# HIGHWAY WORK PROPOSAL

Proposal Number: **048**

<u>STATE ID</u>	<u>FEDERAL ID</u>	<u>PROJECT DESCRIPTION</u>	<u>HIGHWAY</u>	<u>COUNTY</u>
7050-00-72	N/A	Neillsville - Thorp, Hunt Street to STH 29 E	STH 073	Clark
7050-00-73	N/A	Neillsville - Thorp, Rock Creek Bridge to Hunt Street	STH 073	Clark

Addendum No. 02  
 ID 7050-00-72  
 Revised Sheet 65  
 January 29, 2025

PROJECT NO: 7050-00-72      COUNTY: CLARK      HWY: STH 73      SHEET 65

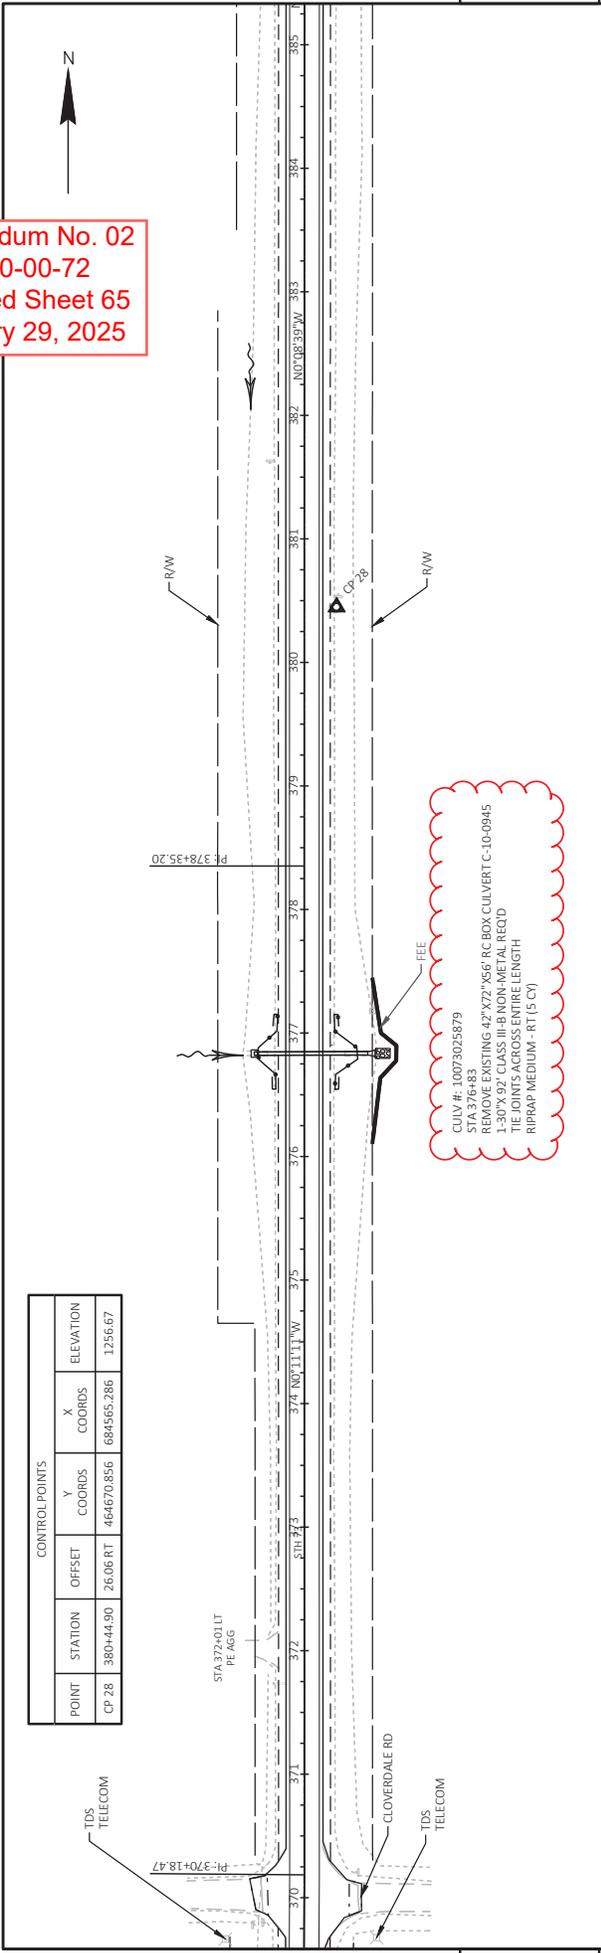
Revised Plan Sheets	
Plan Sheet	Plan Sheet Title (brief description of changes to sheet)
65	Revise culvert pipe note at STA 376+83.
